**MOTOROLA***Customer Support Russia and CIS Region***Service Bulletin RU\_SB048**

**Author:** Alexander Gaiderov, Technical Support  
**Date:** 2004-06-28  
**Subject:** C33x Battery Metering Inaccurate  
**Rating:** Level 3 Authorized

**Products:** C330, C331, C332, & C333

**Photo #2-Bending PCB Batt Connector Negative Pin**

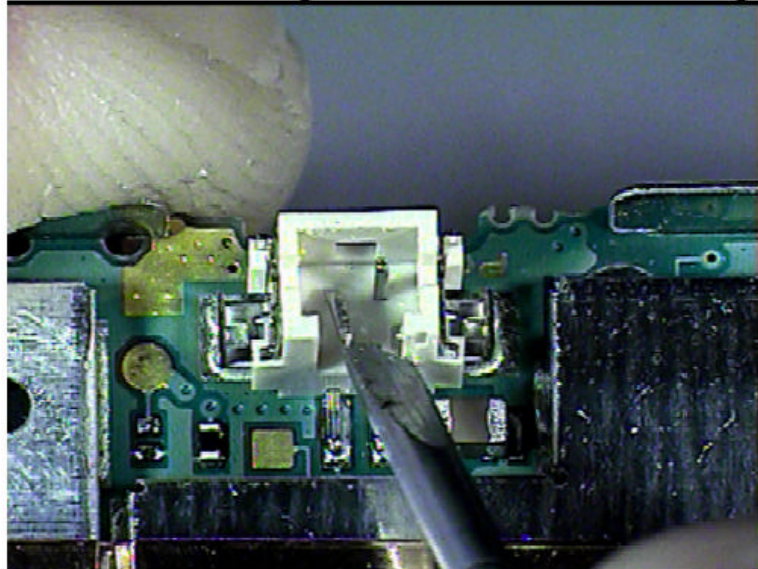
- 1) Disassemble the unit to gain access to the battery.
- 2) Remove the battery from the PCB battery connector
- 3) Using a flatblade jeweler's screwdriver, break off the of the PCB battery connector negative (-) pin by moving the pin back and forth several times until it breaks at the connector's base. Refer to Photos 1 thru 4 below.

**Photo #5-Bending Positive Pin**

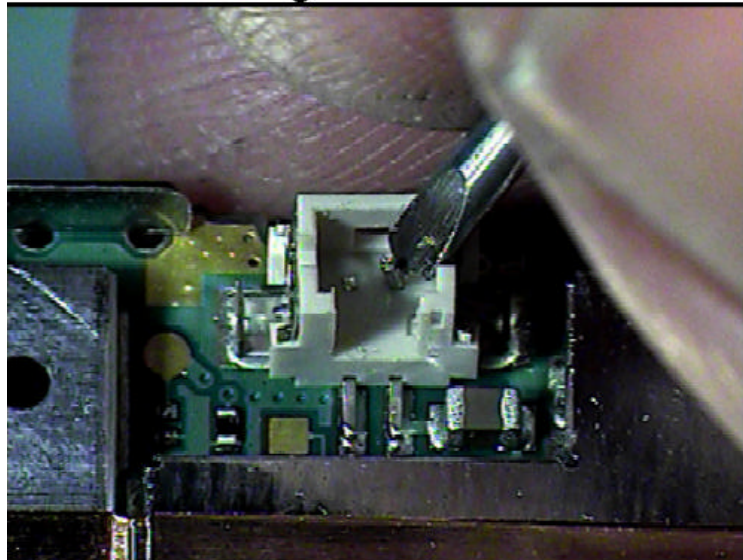
4) Using the flatblade jeweler's screwdriver, bend the PCB Battery Connector positive (+) pin approximately 20 degrees towards the center of the connector. This is to allow clearance between the heat shrink tubing (installed later in this procedure) & the PCB connector body. Refer to Photos #5 & #6.

**Photo #7-Using PCB Batt Connector To Cut Heat Shrink to Proper Length**

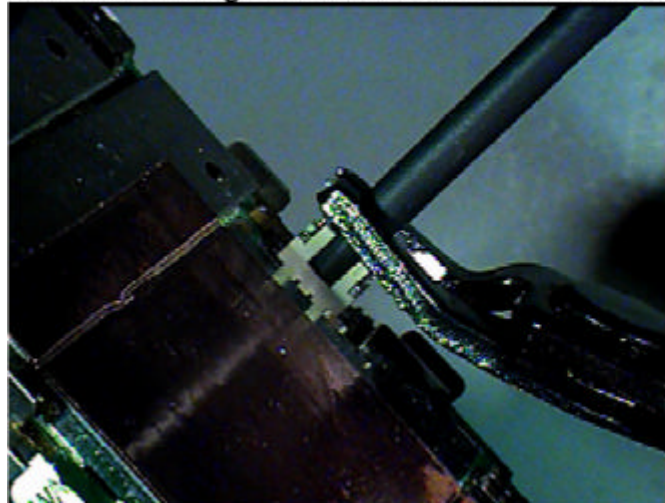
5) Insert a 3/32 diameter heat shrink tubing (3M Part # FP-301) until it fully seats into the PCB battery connector.

6) Using a diagonal wire cutter, cut the heat shrink flush to the top of the connector. **The cut length must not exceed 4mm.** Refer to Photo #7

### Photo #8-Cutting Batt Connector Housing

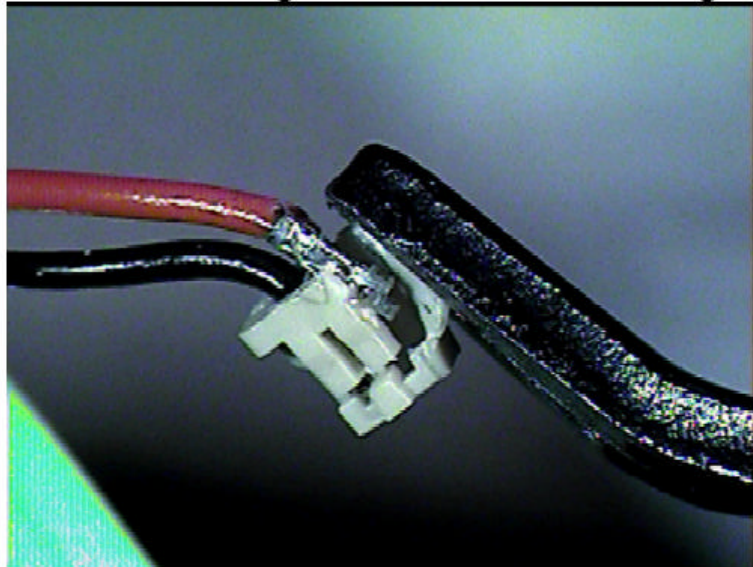
8) Using the diagonal wire cutter, cut the side of the battery connector

housing which is closest to the red lead in order to remove the lead from the battery connector. Use caution to avoid damaging the battery wire or contact pin. Refer to Photo #8.

### Photo #9-Batt (+) Lead Tab Position

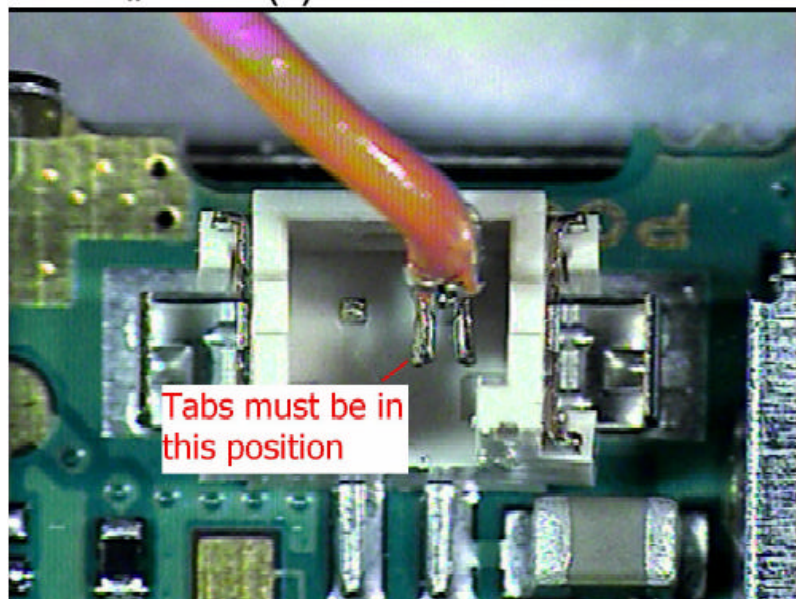
13) Position the the red battery lead pin so it's tabs are facing toward the opening of the PCB batt connector. **The tabs must not face the neg side of the batt connector.** Refer to Photo #9.

**Photo #10-Positive Lead Complete**

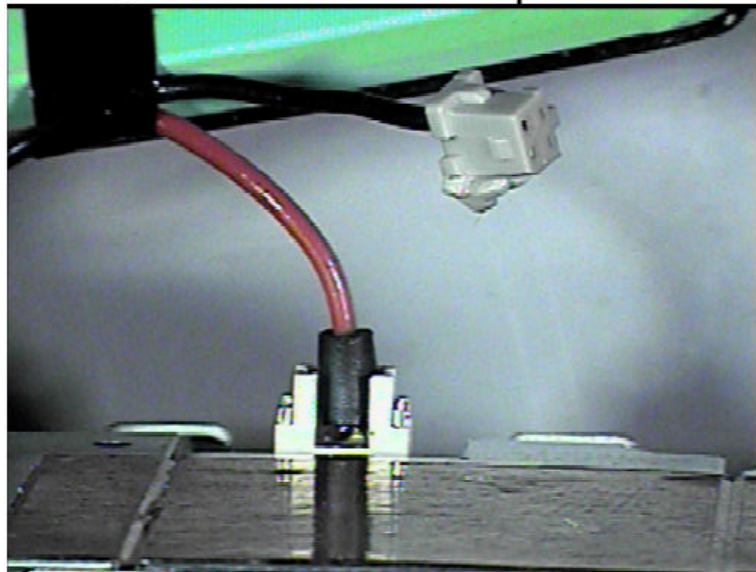
- 14) Attach the battery lead pin to the PCB battery connector positive pin and touch the soldering iron tip to the connection. Use care to avoid excessive heat.
- 15) Verify proper soldering adhesion has taken place by gently pulling on the red lead. If the lead disengages from the PCB connector pin, repeat Steps 11 thru 14.
- 16) Slip the heat shrink tubing over the soldered connection until it fully seats into the PCB battery connector.
- 17) Using a heat gun, apply heat to the tubing. Refer to Photo #10.

**Photo #11-Black Battery Lead Pin Tabs**

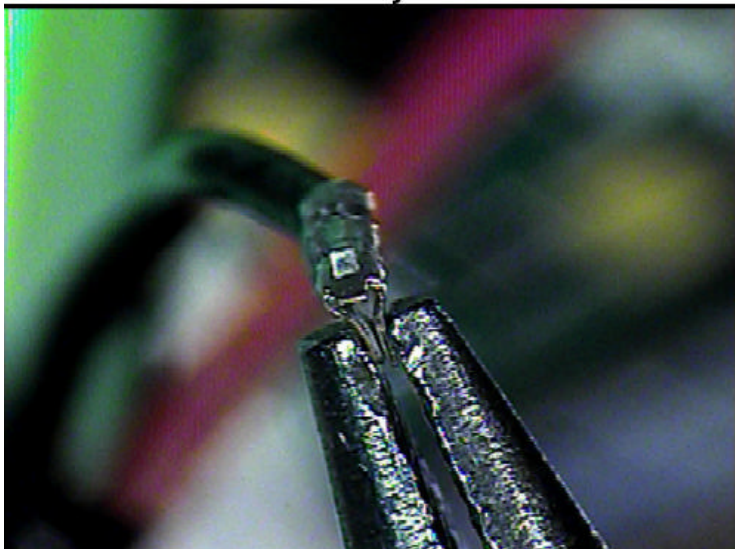
- 18) Repeat Steps 8 & 9 with the black battery lead.
- 19) Squeeze the black battery lead pin tabs together using needle nose pliers. Refer to Photo #11,

### Photo #12-Battery Black Lead to PCB Connection

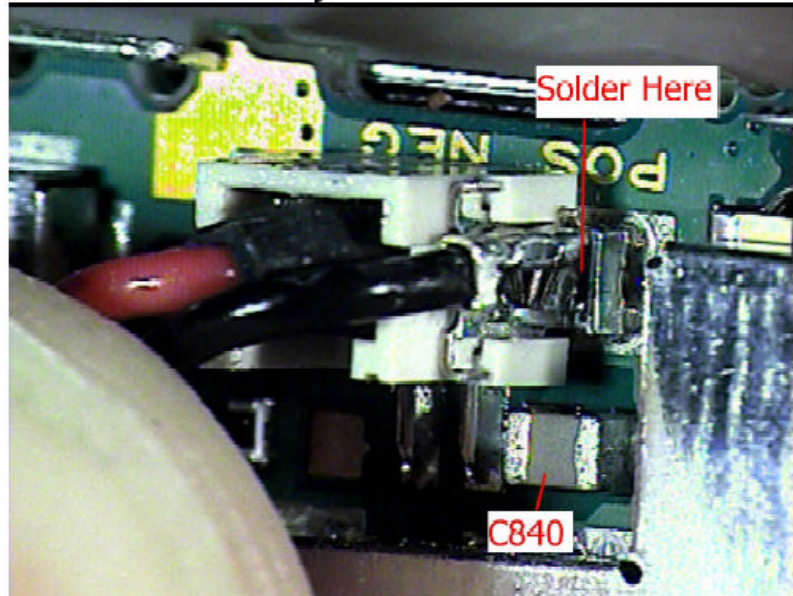
- 20) Tin the lead's contact pin with solder. Avoid excessive heat.
- 21) Add a drop of flux to the pin.
- 22) Insert the pin into the PCB battery connector's metal ground tab which is located on the side of the connector near C840. Ensure the pin is seated fully into the metal tab. Refer to Photo #12

- 23) Solder the black battery lead pin to the connector's ground tab as shown in Photo #12 above.
- 24) Dress the battery leads so they do not exceed the battery height. Refer to Photo #13.
